PASADENA WATER AND POWER

SUBJECT: National Aeronautics and Space Administration (NASA), Jet Propulsion Laboratory (JPL) Technical Memorandum (TM): Additional Investigation Results, January 31, 2007

Review and Comments of NASA's Jet Propulsion Laboratory 31-Jan-07 Technical Memorandum: Additional Investigation Results

REVIEW AND COMMENTS OF NASA'S 31-JAN-07 JET PROPULSION LABORATORY TECHNICAL MEMORANDUM: ADDITIONAL INVESTIGATION RESULTS

Figure 15

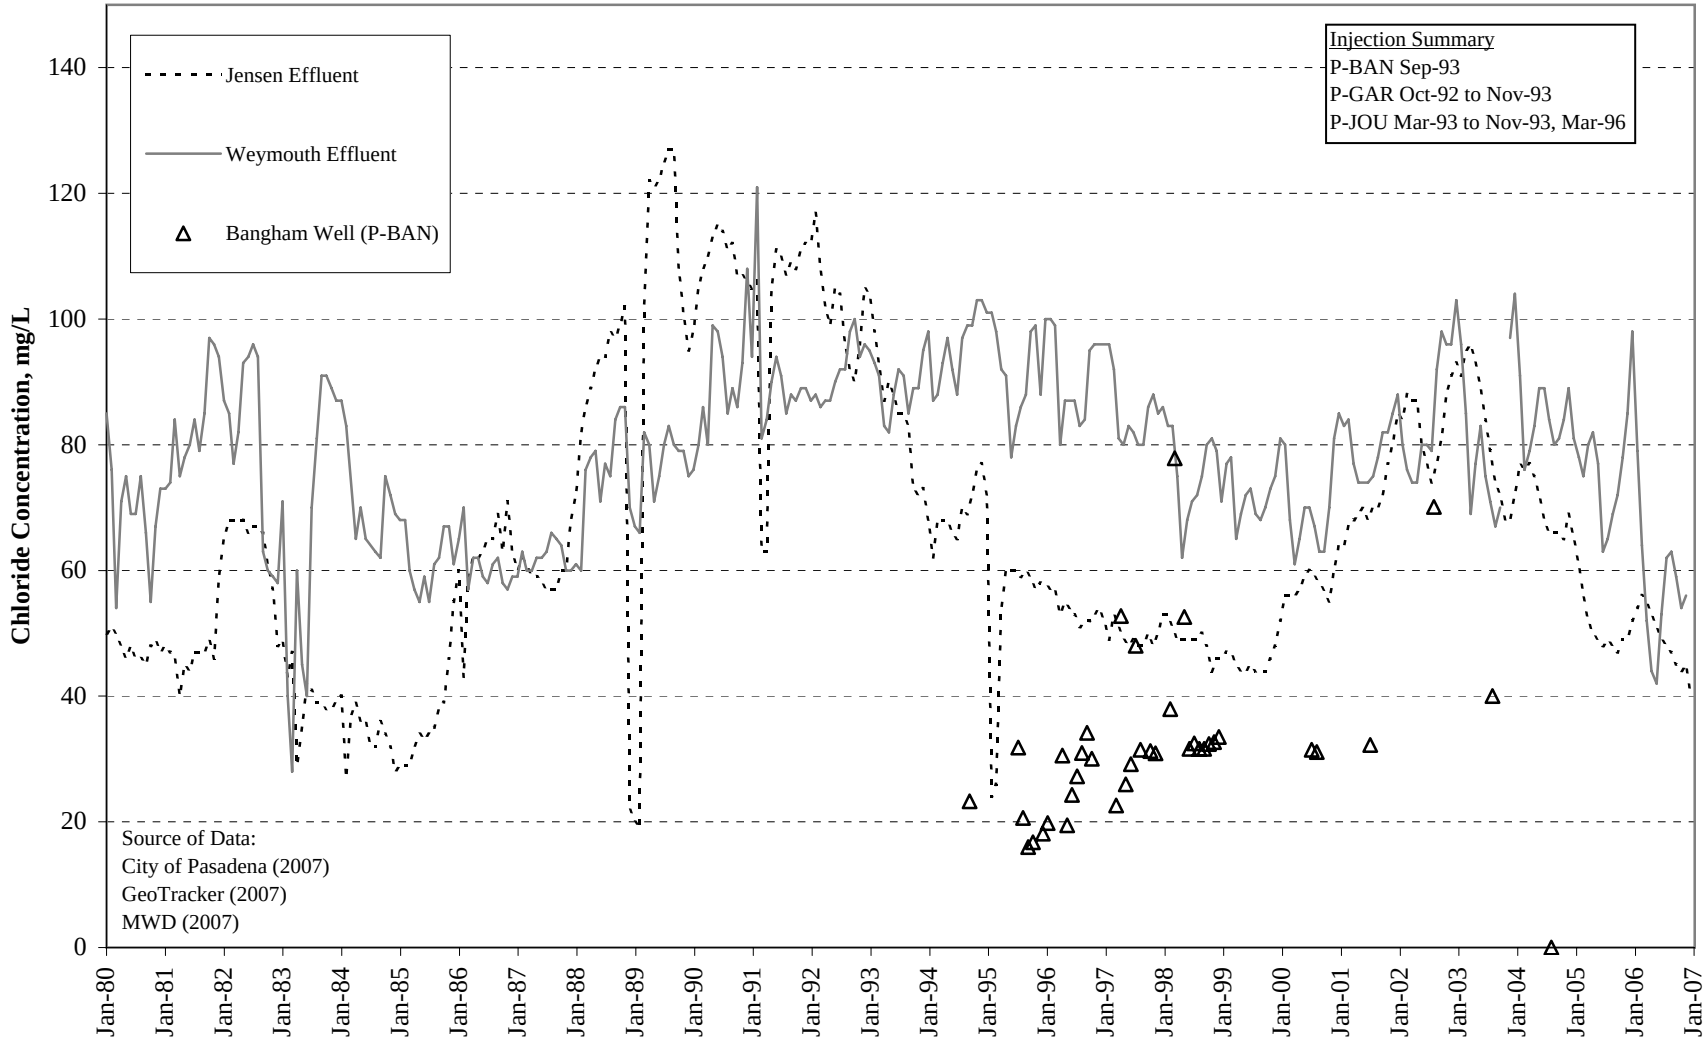
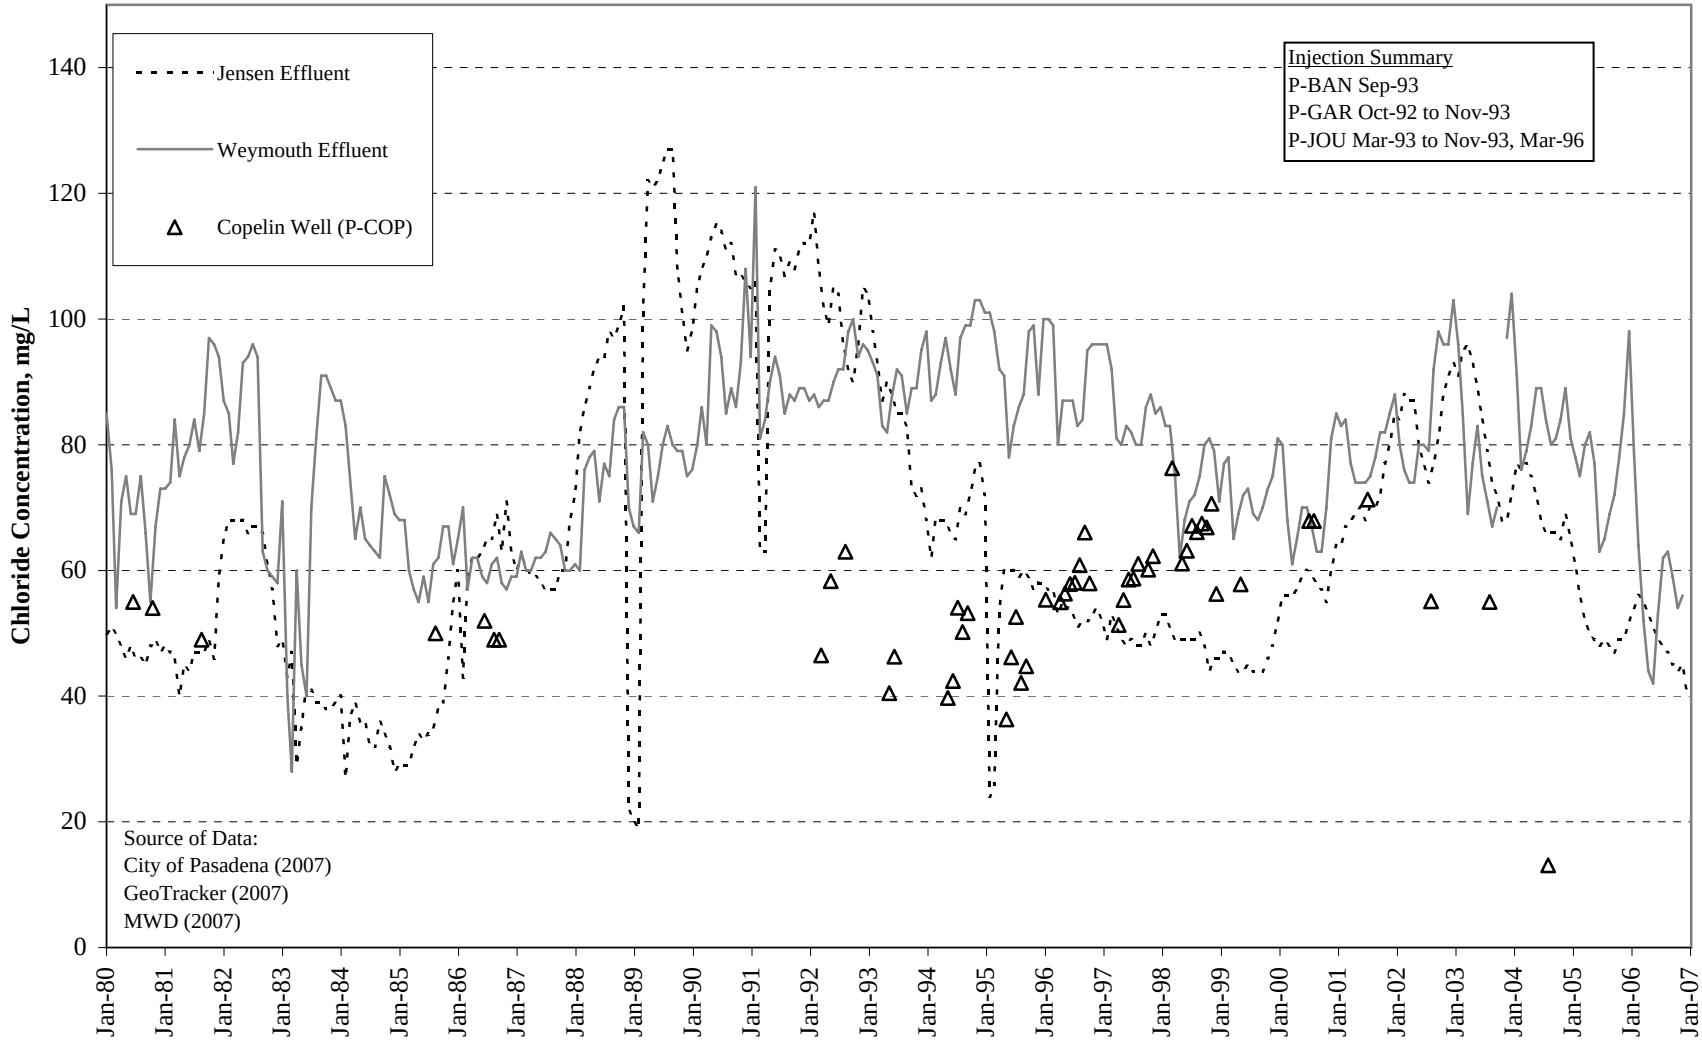
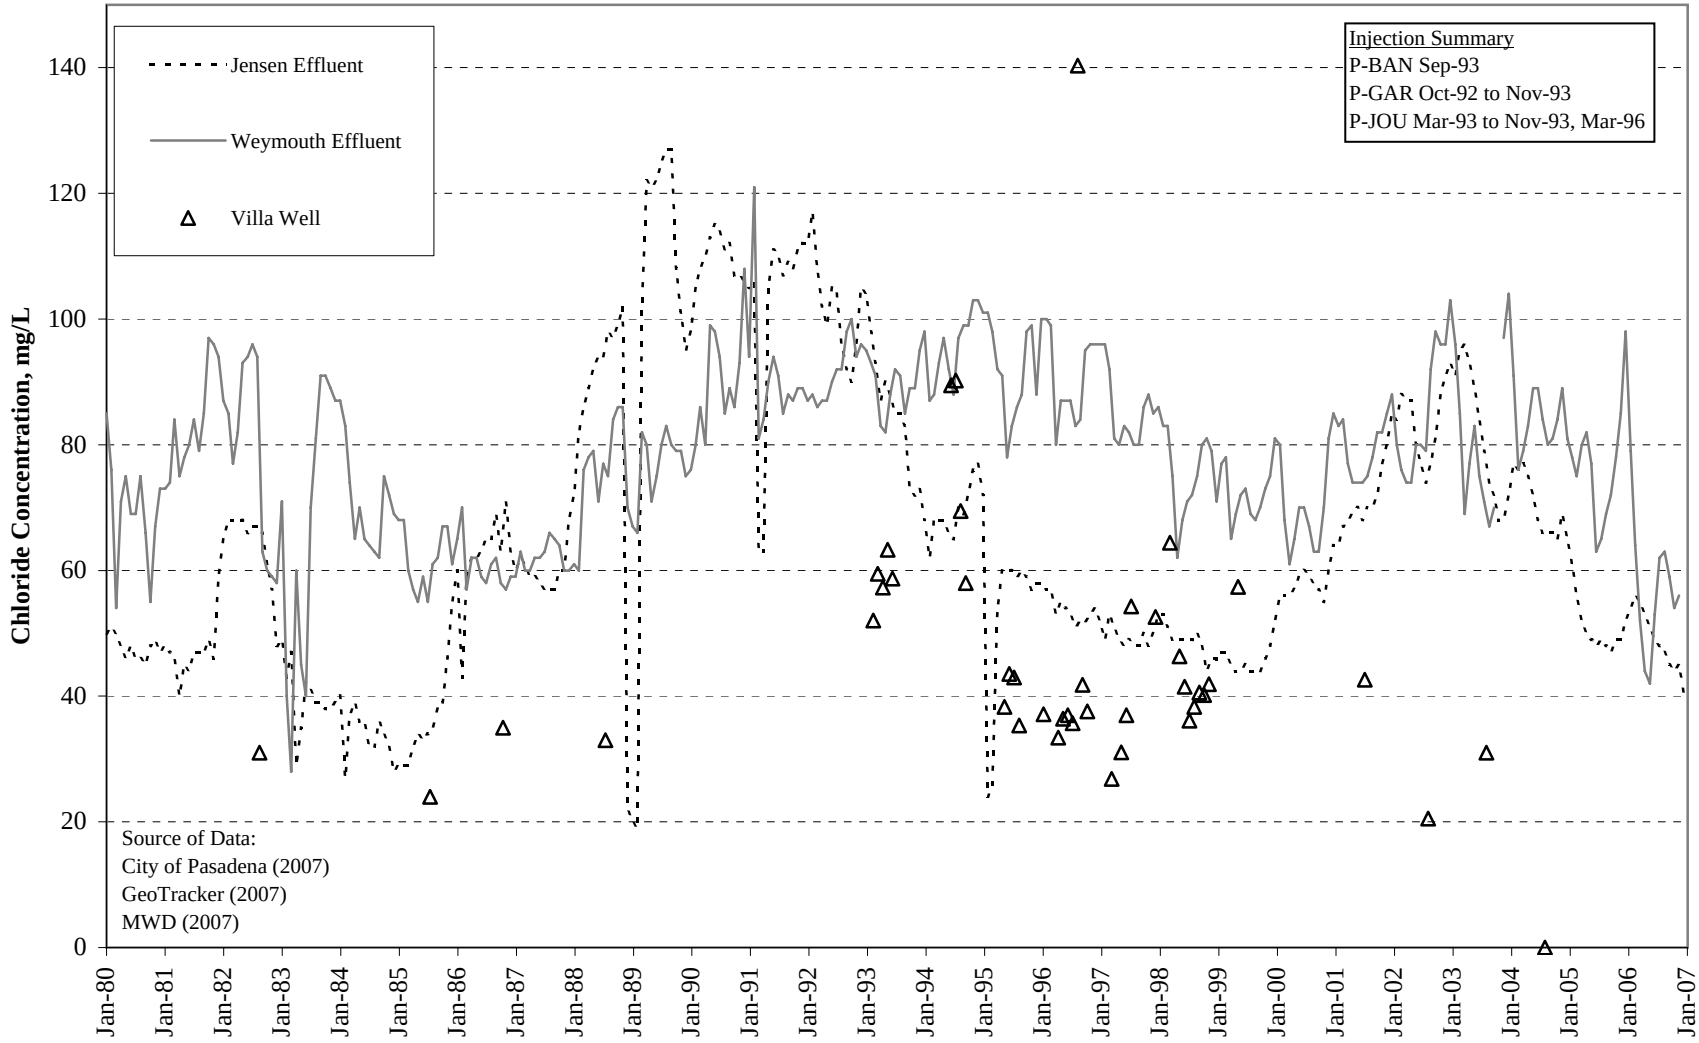
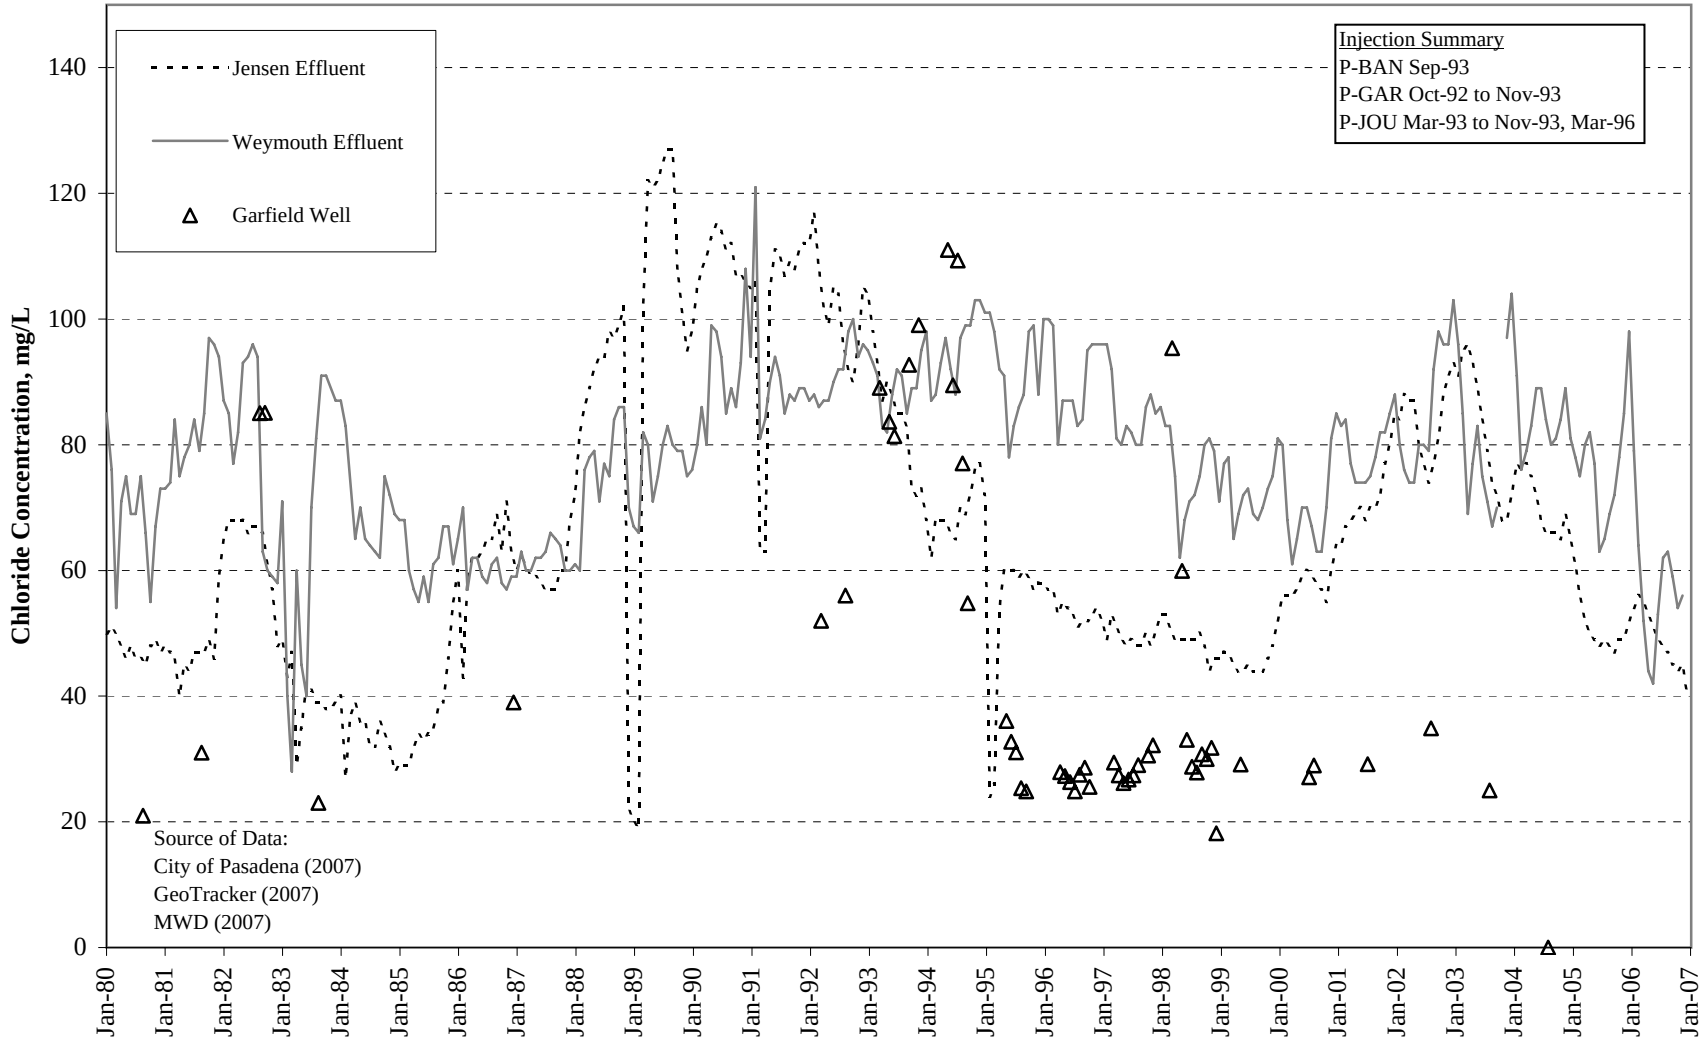
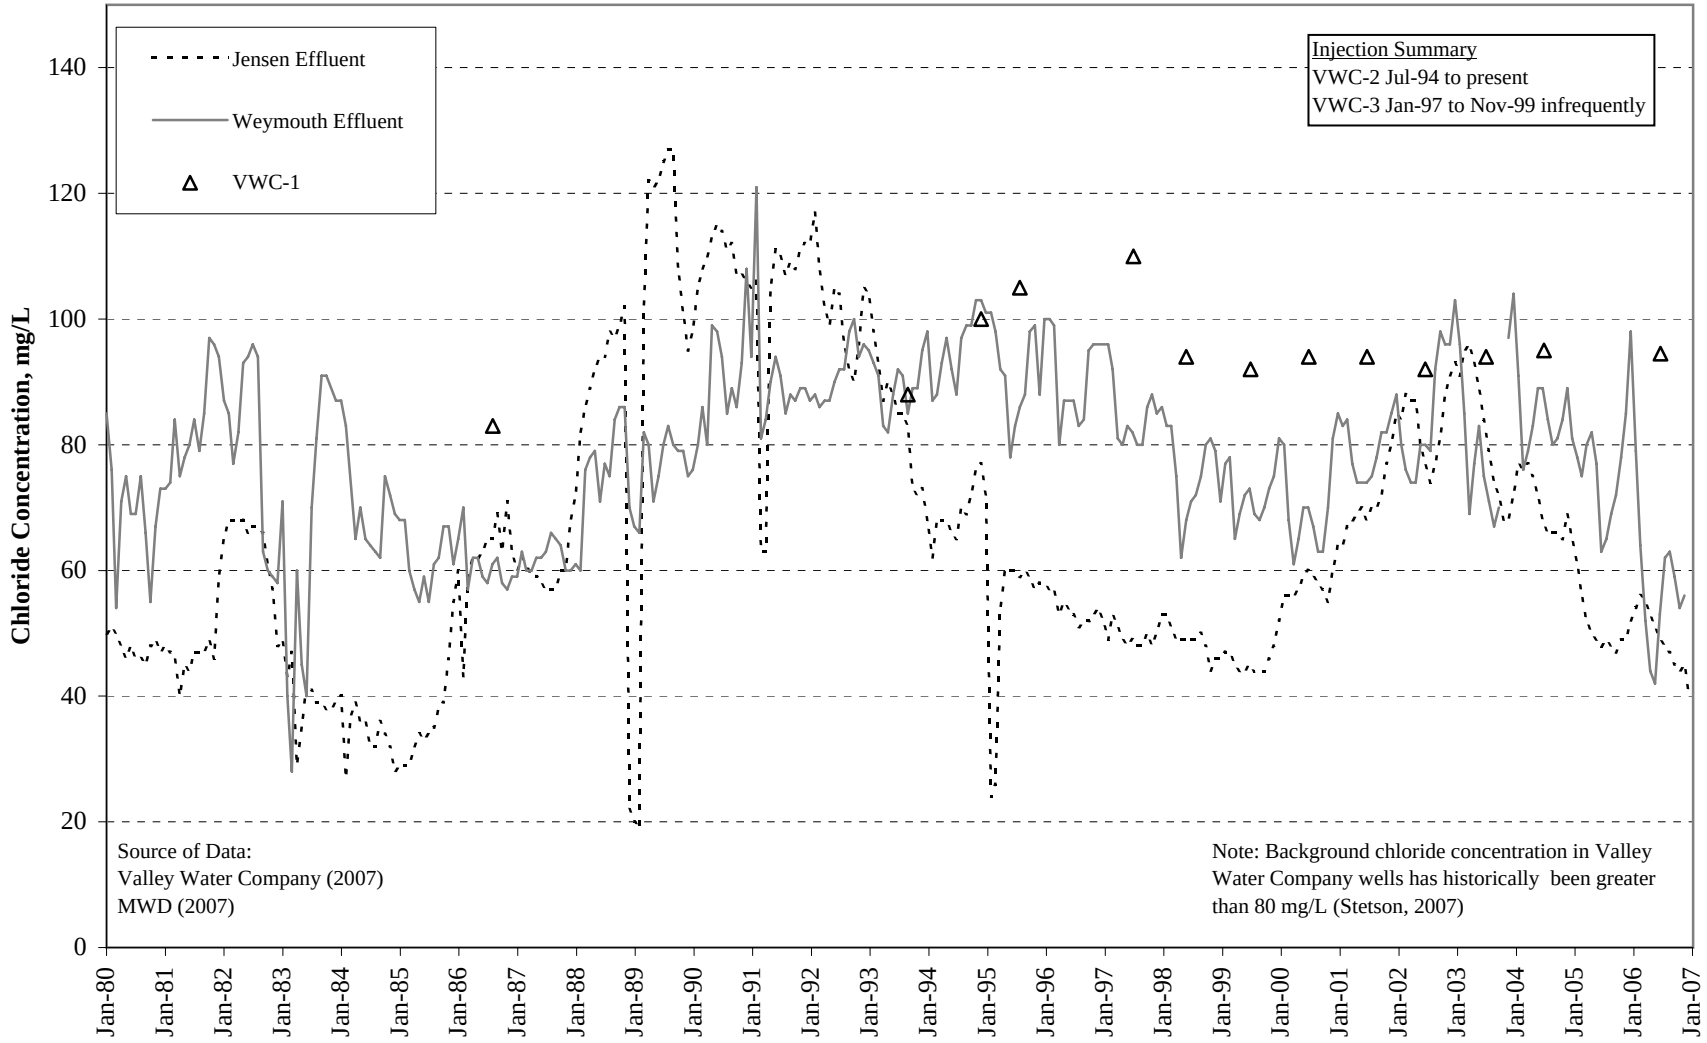
It is agreed that sulfate in the Basin has increased in some areas, possibly due to the importation of Colorado River Water and recharged as return flow including septic tank discharge in unsewered areas. Also, in the Sunset Reservoir and Valley Water Company wells, historical sulfate trends show a range of increases, no changes and decreases as shown in Figures 5 – 31, and summarized in Table 1.

If the mechanism described by NASA for concentrating perchlorate in the ground water to levels above the source/recharge water was valid, it would be expected that other salts, such as sulfate, chloride and TDS would also increase in the ground water to concentrations exceeding the recharge water. Figures 5 through 13 show that sulfate in ground water (both Sunset Reservoir area and Valley Water Company wells) have mostly remained at or below imported Colorado River and State Project water concentrations, while Figures 32 through 36 show perchlorate in ground water significantly higher than concentrations in imported water for wells hydraulically downgradient of the JPL facility.
